| ITEM: 6.5 | REPORT SUMMARY MINOR VARIANCE APPLICATION FILE NUMBER A197/23 |

**MINOR VARIANCE APPLICATION
FILE NUMBER A197/23
236 STORMONT TRAIL, WOODBRIDGE**

| PURPOSE OF APPLICATION: | Relief from the Zoning By-law is being requested to permit a proposed cabana. |

PROPOSED CABANA SITE PLAN

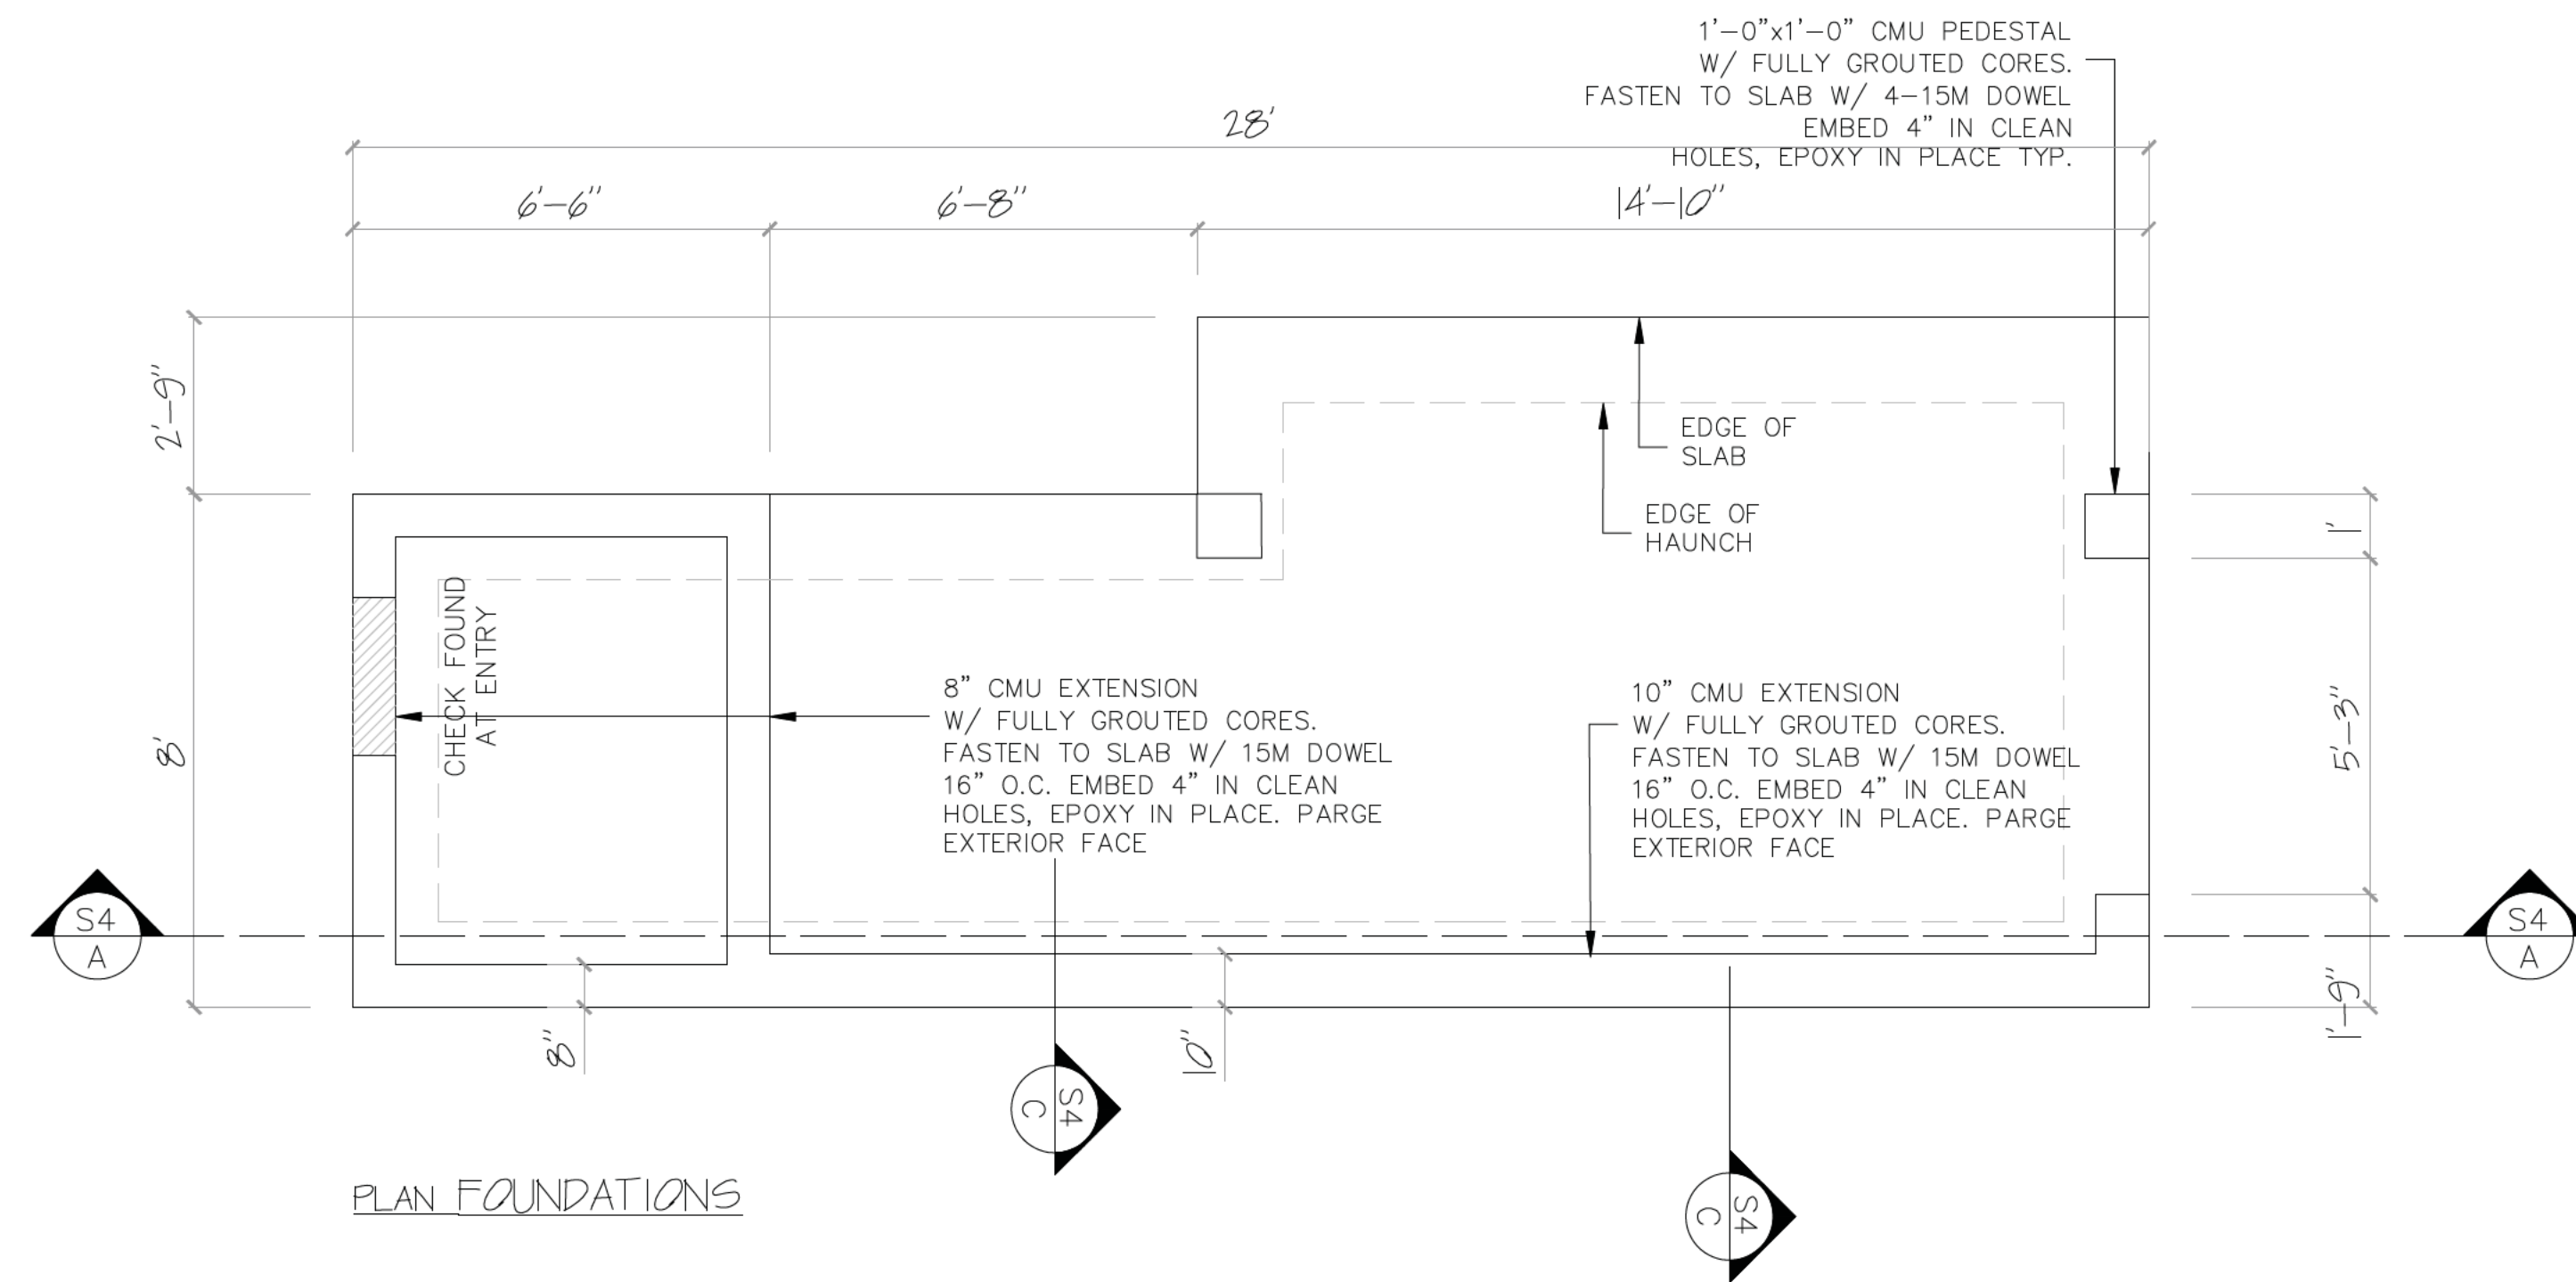
The proposed cabana can increase to the existing storm drainage flows having adverse effects on the neighbour's property. The Owner / Applicant shall ensure that positive drainage is achieved and that no surface drainage problems are created on adjacent private or public lands because of the construction in accordance with the City's Engineering standards. It's important note that any in-

ground structure exceeding 10 m² necessitates a Grading Permit. Once the Grading Permit is obtained, please reach out to the Development Engineering Reviewer to clear the Condition imposed on this application. The Development Engineering Department does not object to the Minor Variance application A197/23, subject to the following condition(s):

The Development Planning Department has no objection to Variances 1 through 3 to permit encroachments into the minimum required distances from the rear lot line (Variance 1) and interior side lot line (Variances 2 & 3) for the proposed Cabana. The rear lot line abuts a woodlot and therefore staff are of the opinion that the proposed Cabana will have no direct massing or visual (privacy) impacts on the property to the north. Variances 2 and 3 are to permit the proposed cabana to have an encroachment having a minimum distance of 0.60 metres measured from the wall (Variance 2) and 0.26 metres measured from the eaves of the Cabana (Variance 3).

unique shape and the relatively rectangular footprint of the dwelling, the interior side yards widen the further away from the front lot line one travels. The east interior side yard setback for the shed expands from 0.60 metres to 1.96 metres at its greatest extent. This triangular area between the proposed Cabana and east interior side lot line provides sufficient space to accommodate the proposed vegetative screening (five plantings) spanning over half the Cabana's east wall. Therefore, the proposed structure is not anticipated to have adverse use (privacy) or massing impacts on the neighbouring property to the east (232 Stormont Trail) and the 0.60 metre minimum side yard setback from the Cabana provides sufficient space for maintenance and access.

| Development Engineering Recommended Conditions of Approval: | The Owner/Applicant shall submit an application and obtain an approved Grading Permit before initiating any work on the property. The Final Lot Grading and/or Servicing Plan will be required for the Grading Permit Application. Please visit the Permits page of the City of Vaughan's website: Permits City of Vaughan to apply for a Grading Permit. For any inquiries regarding the Grading Permit, please email DEPermits@vaughan.ca |

ELEVATION WEST

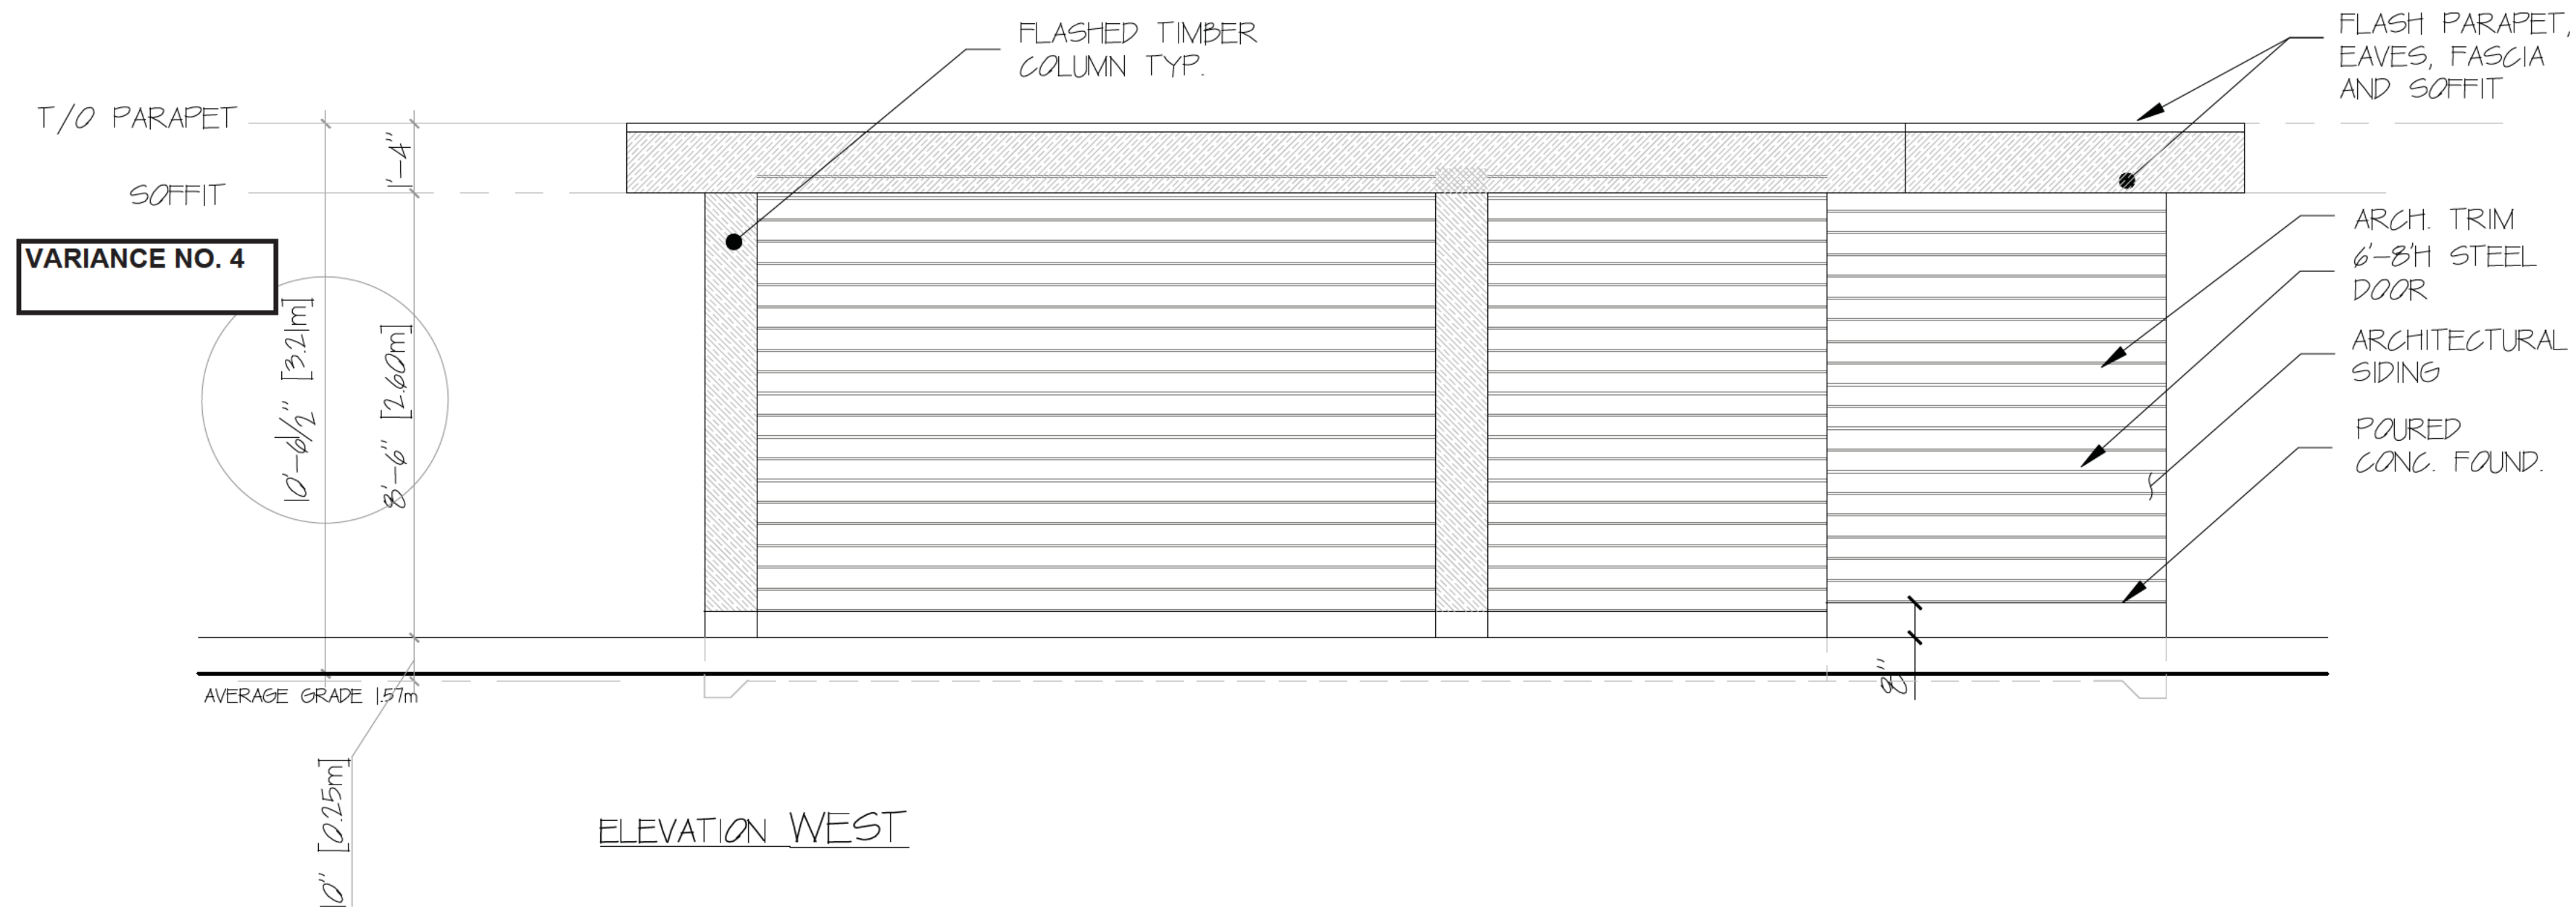
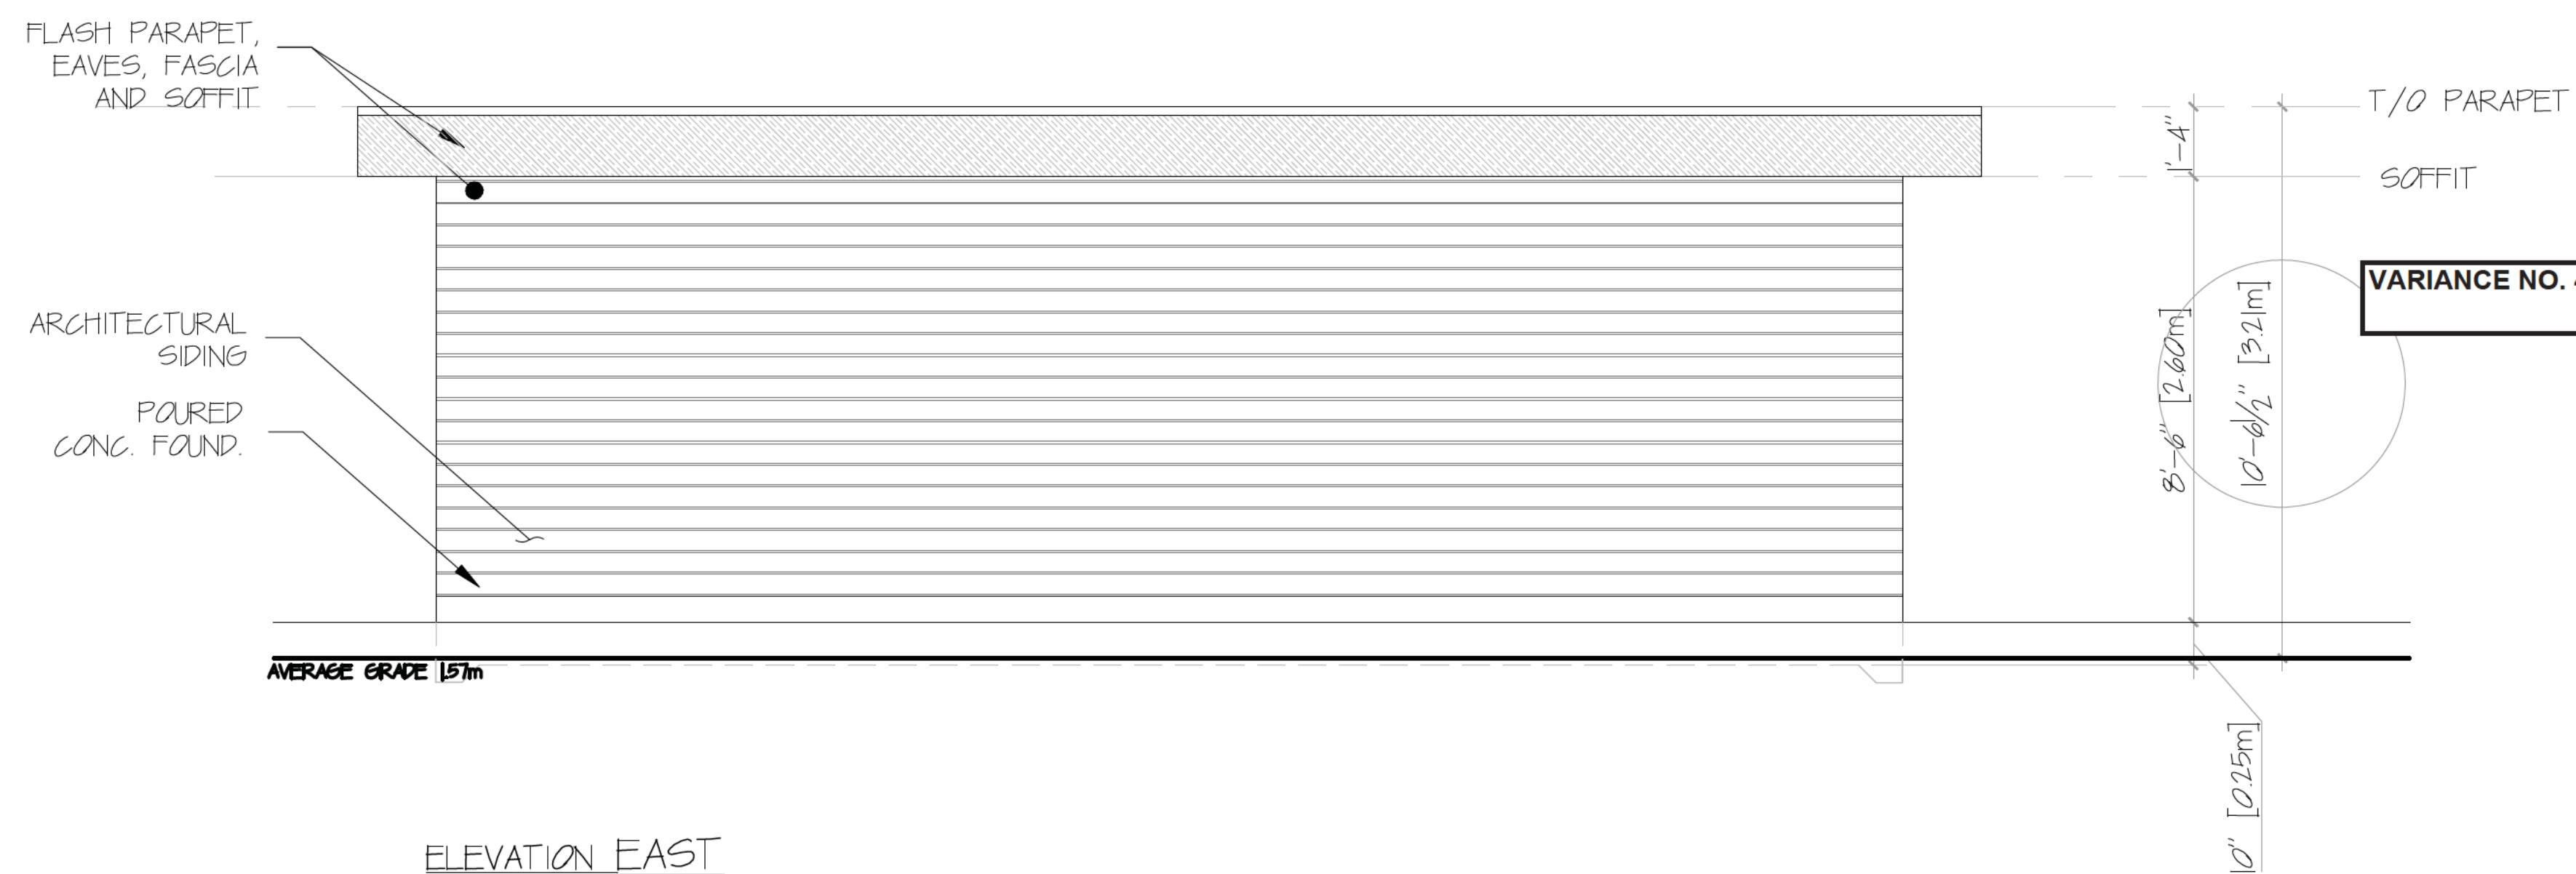
The Development Planning Department has no objection to Variance 4 to permit a 0.21 metre increase to the maximum height of an accessory building. The Cabana is proposed on the east side of the rear yard, east of the existing Pool, and south of the rear lot line which abuts a woodlot. The accessory structure provides sufficient space for access and maintenance and to accommodate proposed vegetative screening that spans over half of the east wall of the Cabana. Five (5) *Carpinus Betulus* 'Fastigiata' plantings are proposed along a portion of the east interior side lot line to provide vegetative screening to assist in buffering most of the Cabana from the abutting property to the east (232 Stormont Trail). No adverse massing or use impacts are anticipated to 232 Stormont Trail. The introduction of the canopy does not adversely impact the functionality of the rear yard and pool access.
